Product Change Notification

Date Issued :	June 04, 2025	PCN Number :	516625
Reason for Change :	Change to Product		
Description of Change :	Receptacle shells were updated (notch added) to improve retention force		
Reason for Short Notice :	Corrective Actions		
Assessment of Change :	No change to parts - Form/Fit/Function SPC / Capability Studies		
Planned Implementation Date :	October 17, 2025		
Customer Sample Availability Date:	July 04, 2025		
Last date to request Samples by Customer :	June 06, 2025		
Please note if Samples are not requested as per Customer Samples Request date, it may take additional 4-6 weeks to arrange Samples.			
Traceability Code Markings / Date :	Product made after planned implementation date can contain the change

2156740051 Revision A

After Picture

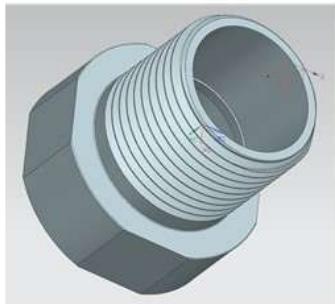
- The shells will be modified to improve the epoxy adherence and avoid rotated insert, see spread sheet to find shells P/N and impacted FGs
- Product Impact
 - “No impact to fit, form or function”
- Part Number Impact
 - See attached spread sheet
- The retention force will be evaluated for one FG per updated shell
- PCN will be implemented once all required qualification/ validation has been completed, and all necessary approvals have been obtained.

Before

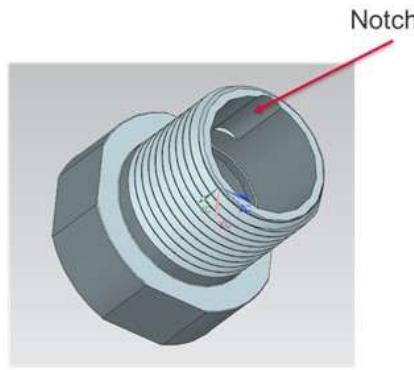
Additional information
